NTSB No. CEN15MA290

Airbus Helicopters Service Bulletin No. AS350-67.00.64 (63 Pages)

SUBJECT: ROTOR FLIGHT CONTROLS - Double hydraulic servocontrols

"HYDR" test indication for double hydraulic servocontrols
 Corresponds to modification 074622

Figure 4

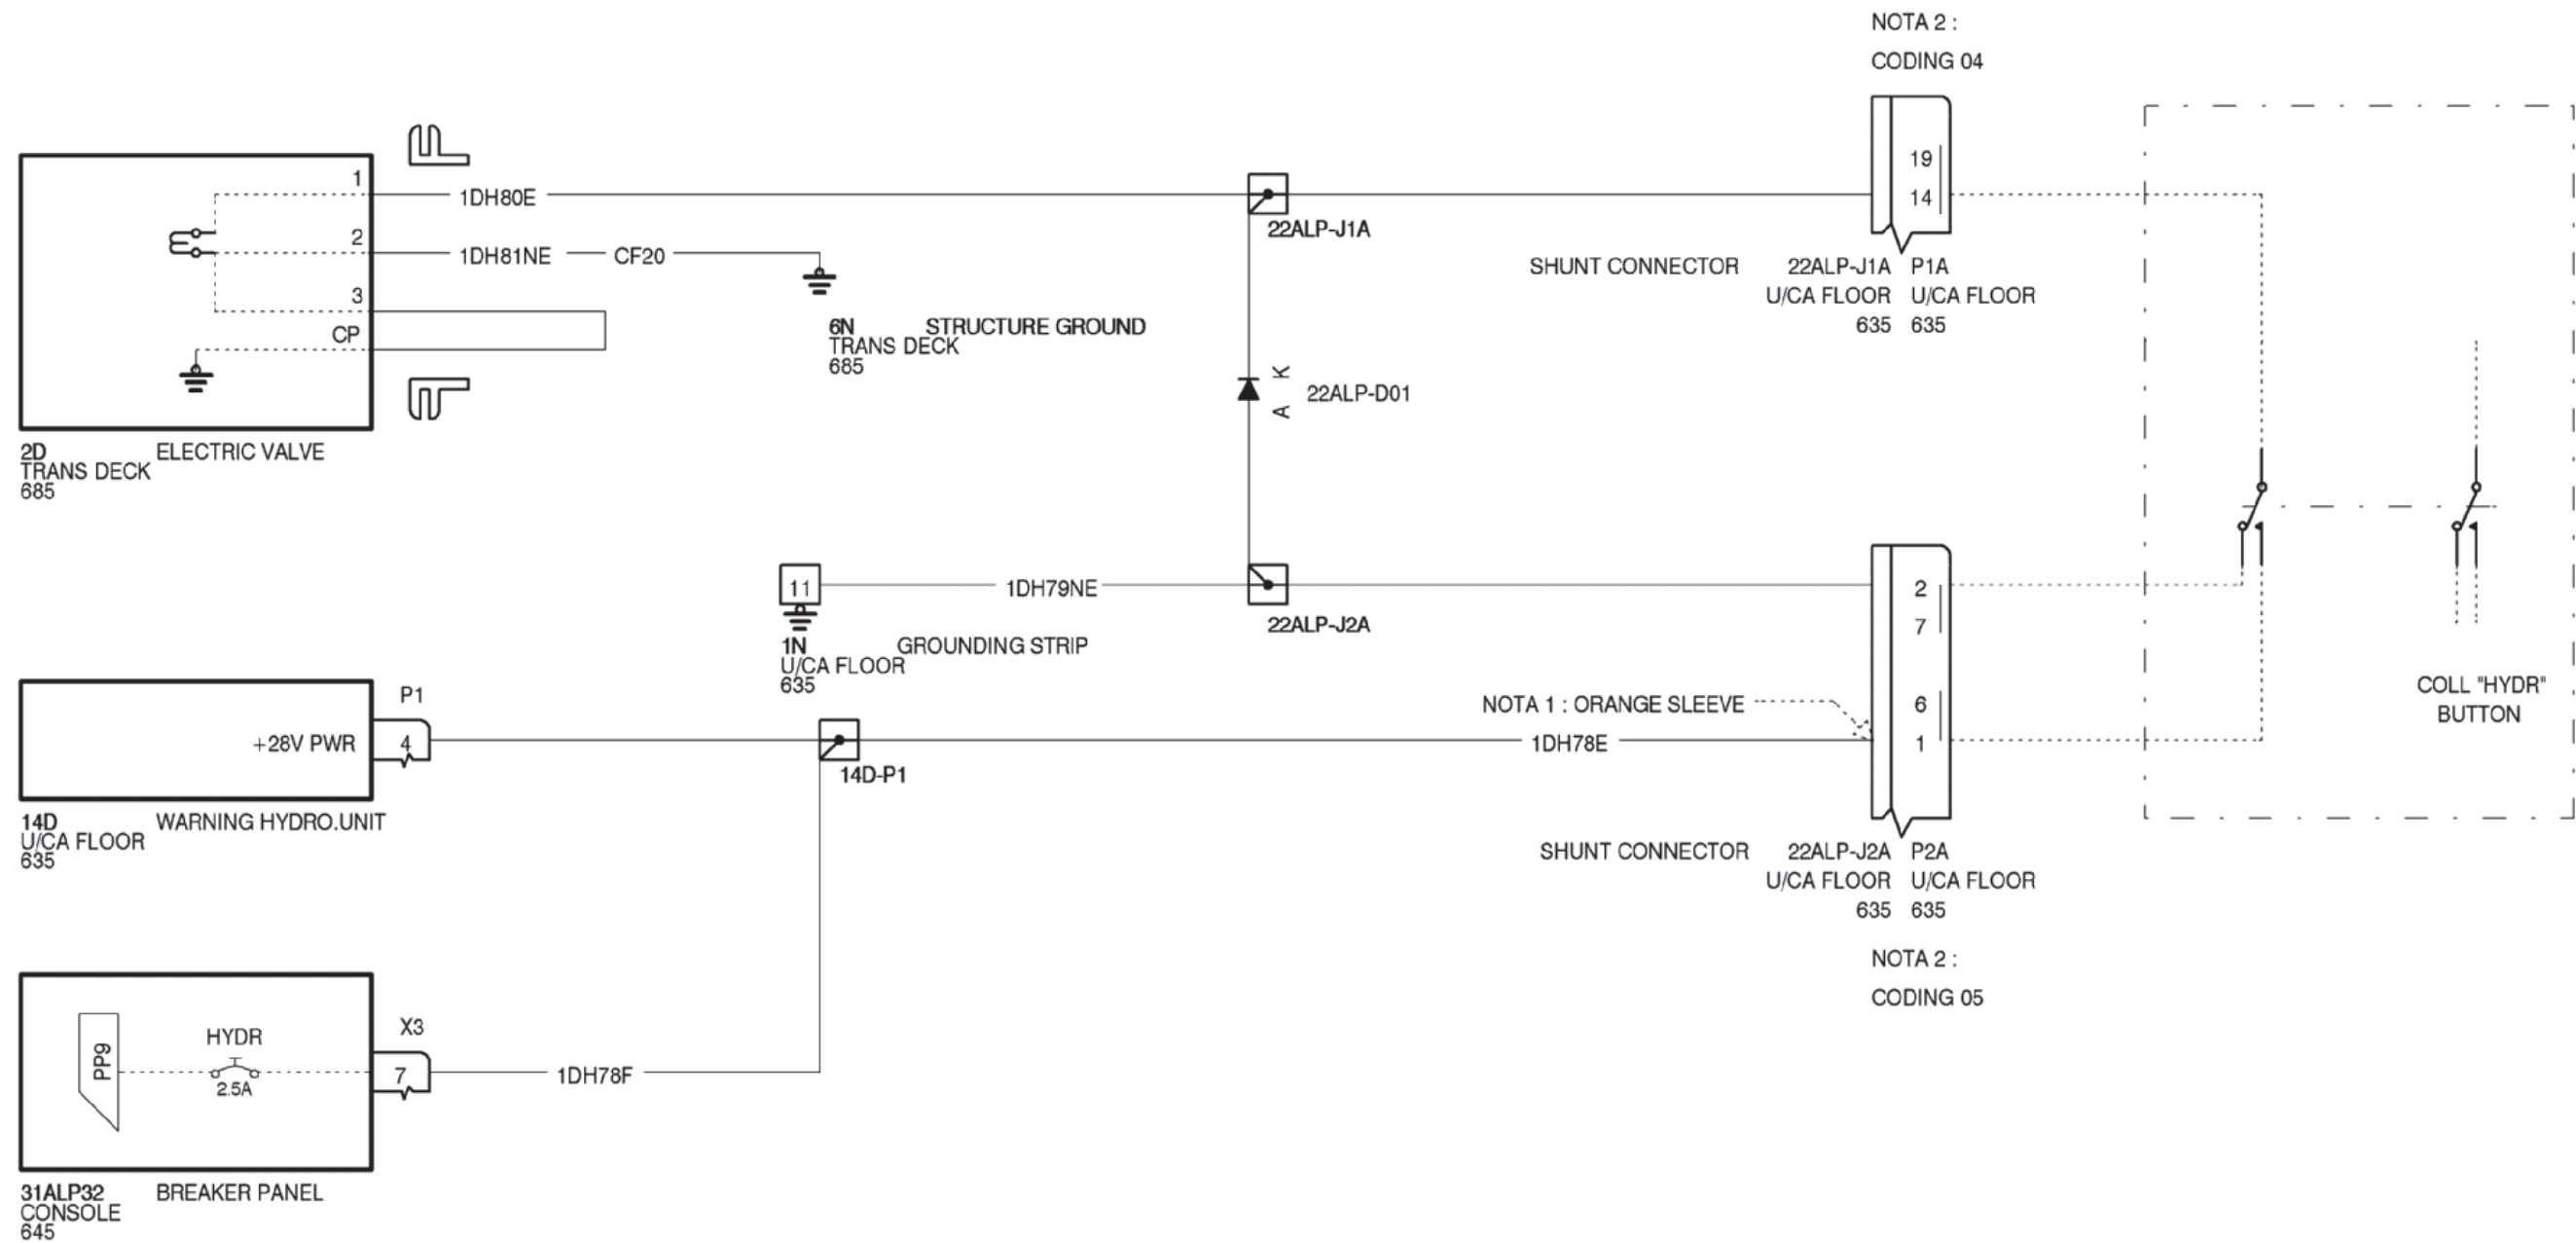
3.B.2.b.1. For helicopters POST MOD 073450 and PRE MOD 075601 (Figures 1, 2, 4, 5, 12 and 13)

- Cut and discard the binding clamps (not shown on Figures) that hold the electrical harnesses.
- Install base (3) on relay support (14) (Figure 1) with its bolts and nuts.
- Route the wiring using sets of wires and markers (1) and (33) and wire to contacts (4), (8), (10) and (11), ground contacts (12) (refer to appendix 4.A.), extensions (9) and (19), module (5) and its adapter (7), as per Figures 2, 4, 5, 12 and 13.
- Carry out a continuity test of the modified wiring.
- Install timer relay (2) on base (3).
- Attach the electrical harnesses with binding clamps (31) or (32) (not shown on Figures).

Figure 6

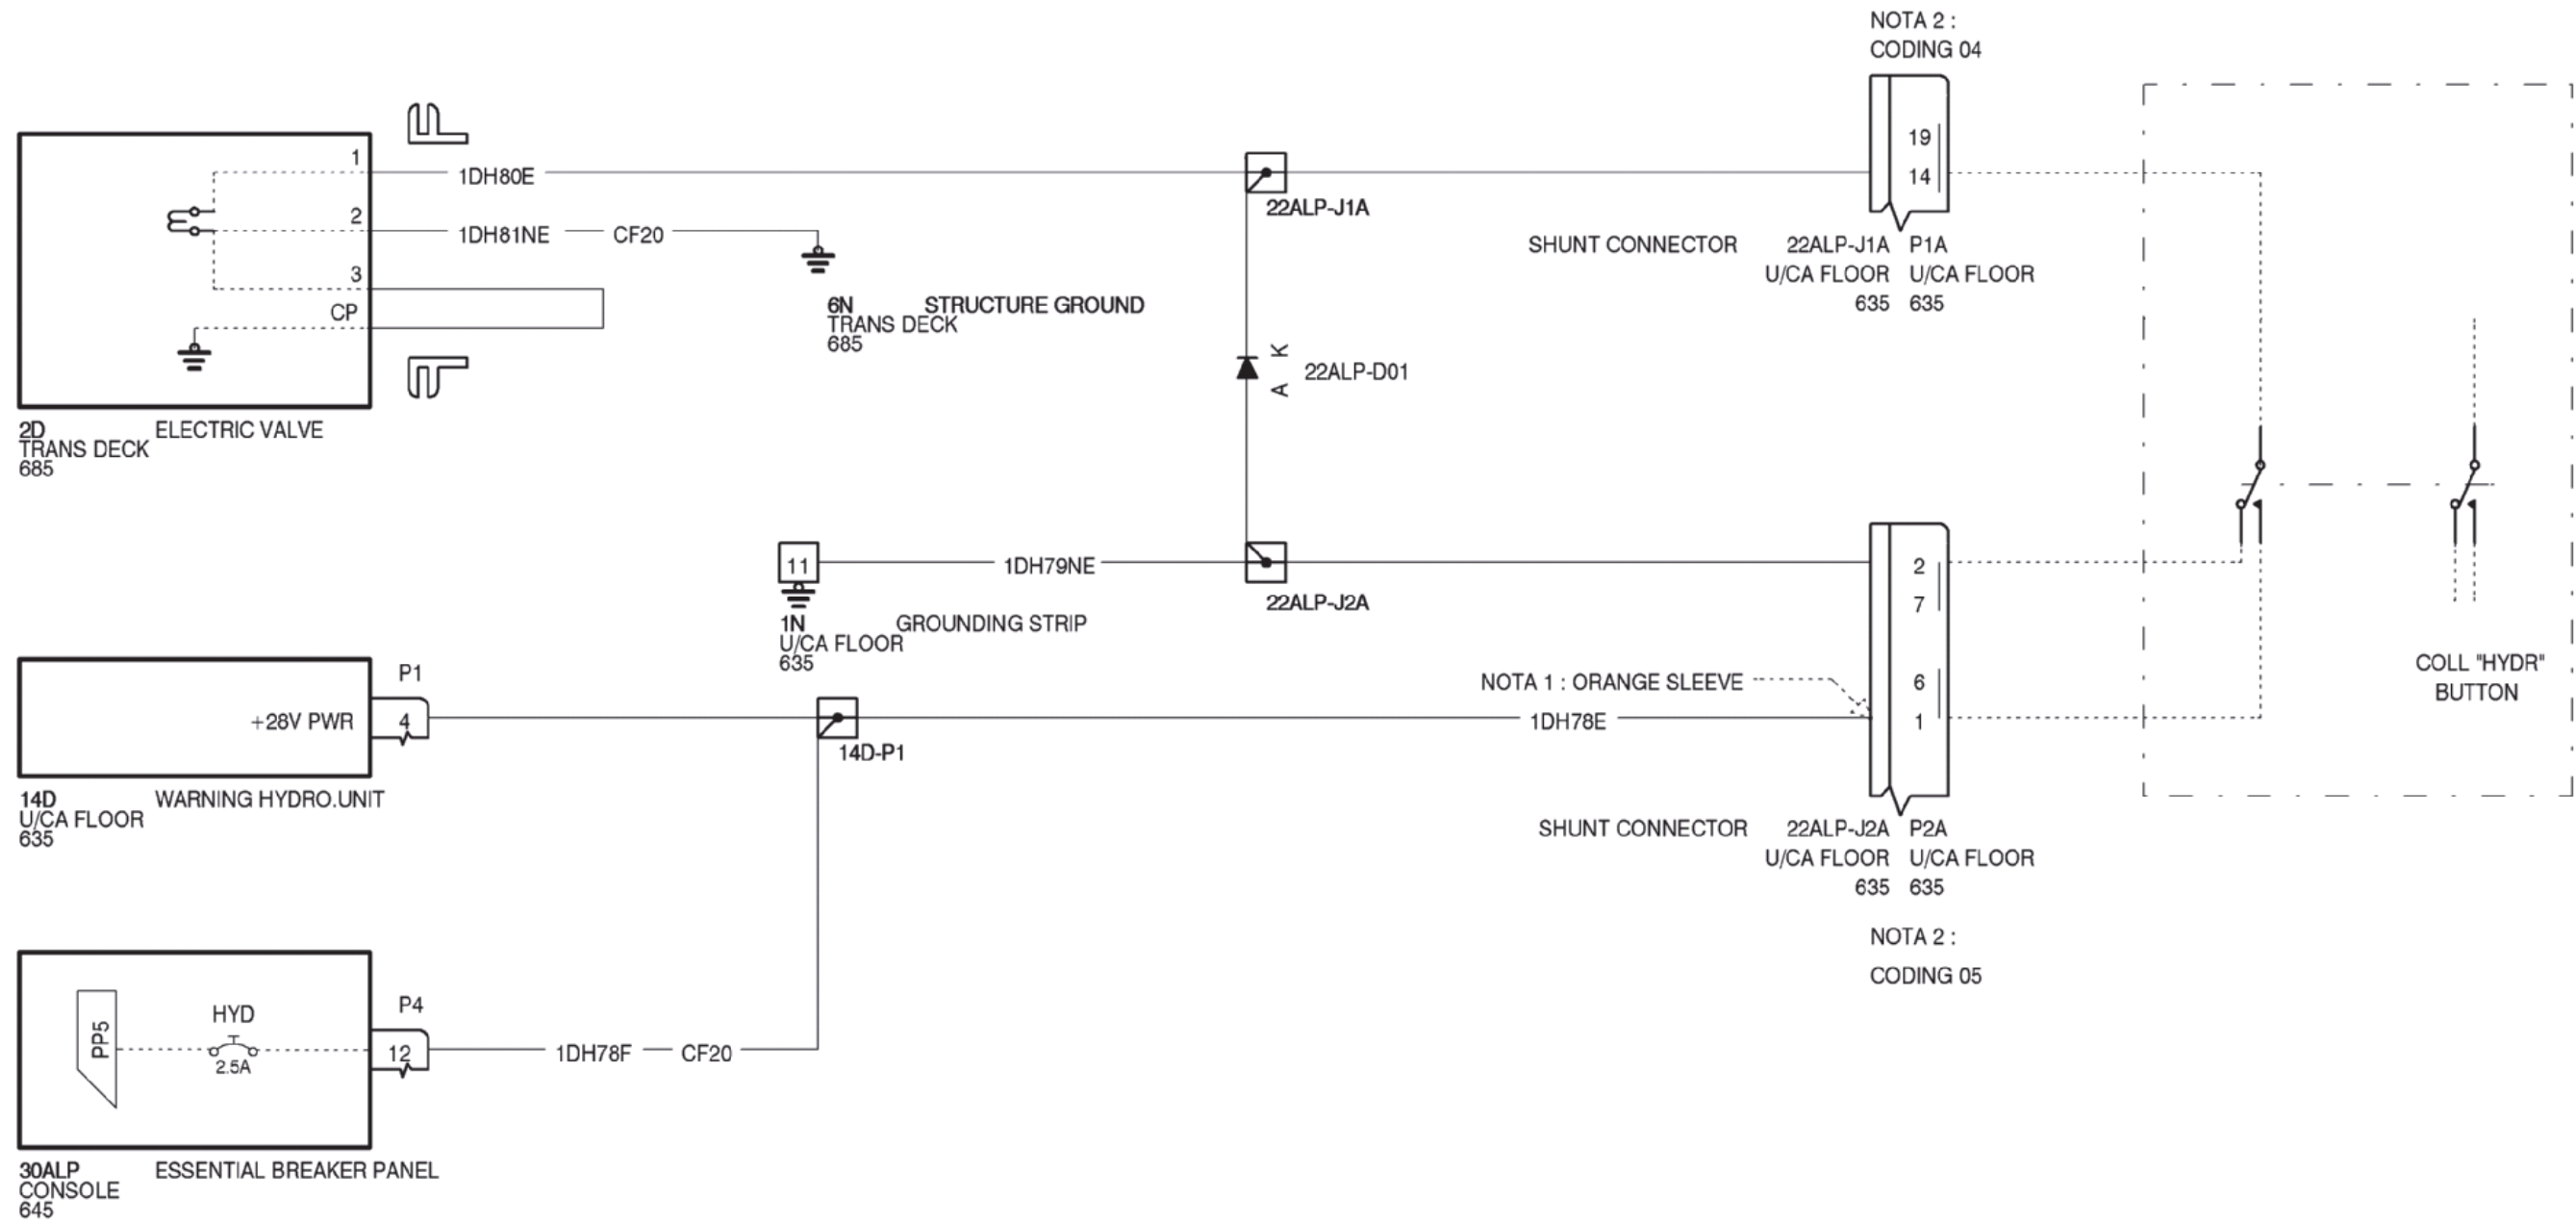
3.B.2.b.2. For helicopters POST MOD 075601 and PRE MOD 074280 (Figures 1, 2, 6, 7, 12 and 13)

- Cut and discard the binding clamps (not shown on Figures) that hold the electrical harnesses.
- Install base (3) on relay support (14) (Figure 1) with its bolts and nuts.
- Route the wiring using sets of wires and markers (1) and (33) and wire to contacts (4), (8), (10) and (11), ground contacts (12) (refer to appendix 4.A.), extensions (9) and (19), module (5) and its adapter (7), as per Figures 2, 6, 7, 12 and 13.
- Carry out a continuity test of the modified wiring.
- Install timer relay (2) on base (3).
- Attach the electrical harnesses with binding clamps (31) or (32) (not shown on Figures).

Figure 8

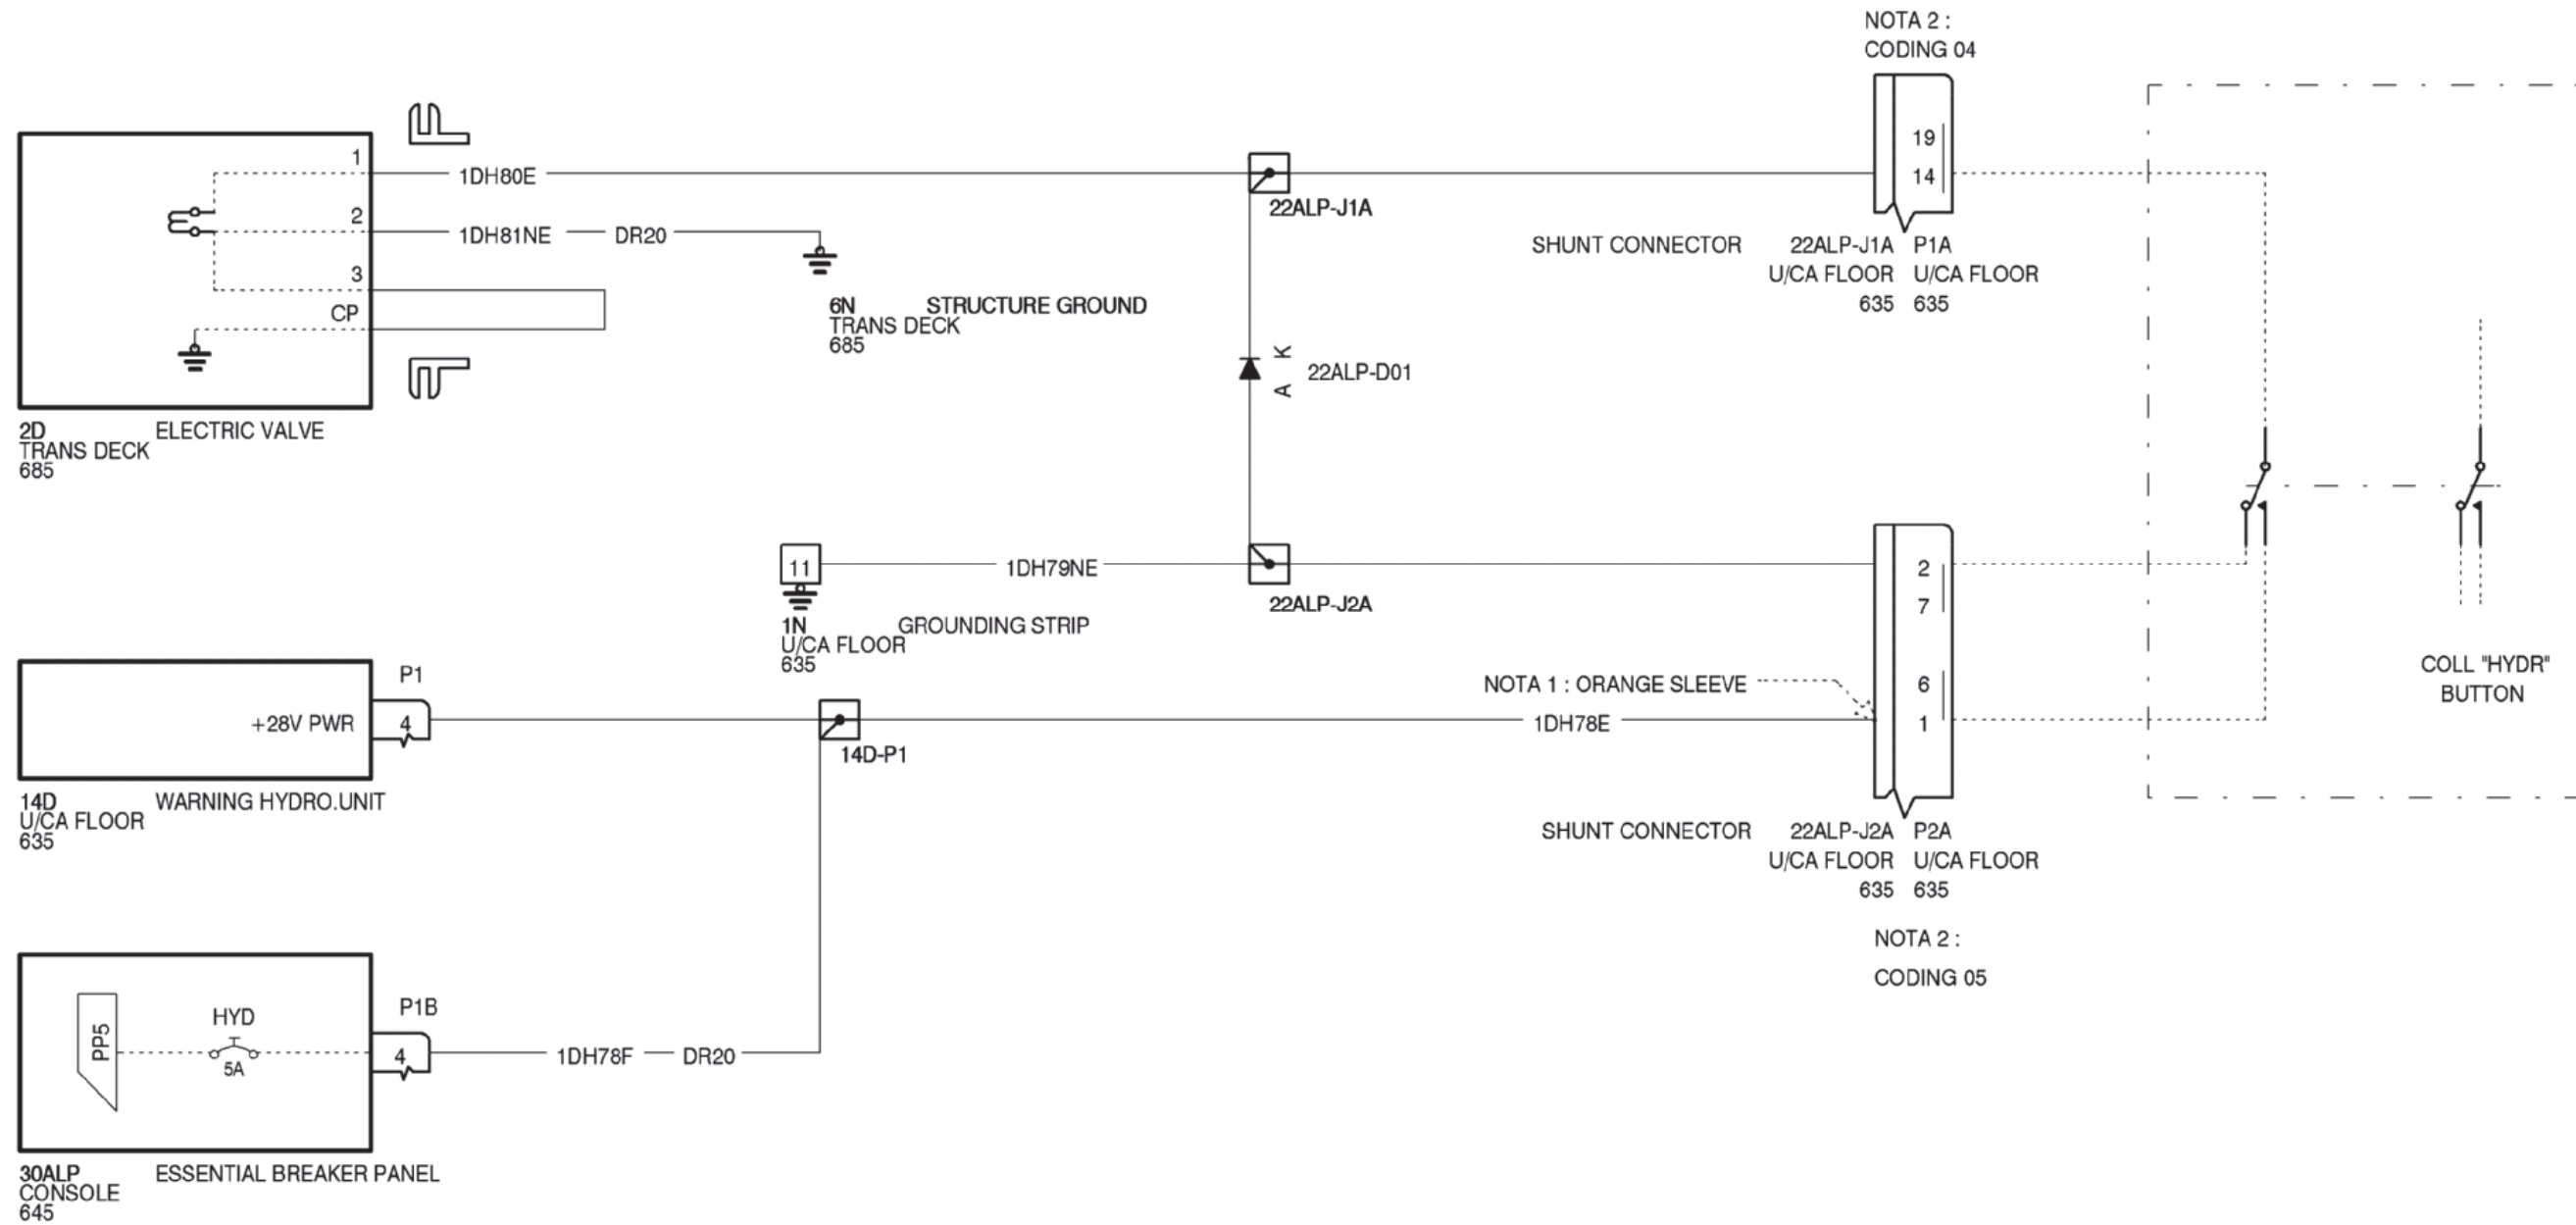
3.B.2.b.3. For helicopters POST MOD 074280 and PRE MOD 075606 (Figures 1, 3, 8 and 9)

- Cut and discard the binding clamps (not shown on Figures) that hold the electrical harnesses.
- Install base (3) on relay support (14) (Figure 1) with its bolts and nuts.
- Route the wiring using sets of wires and markers (1) and (33) and wire to contacts (4), (8), (10) and (11), ground contacts (12) (refer to appendix 4.A.), extensions (9) and (19), module (5) and its adapter (7), as per Figures 3, 8 and 9.
- Carry out a continuity test of the modified wiring.
- Install timer relay (2) on base (3).
- Attach the electrical harnesses with binding clamps (31) or (32) (not shown on Figures).
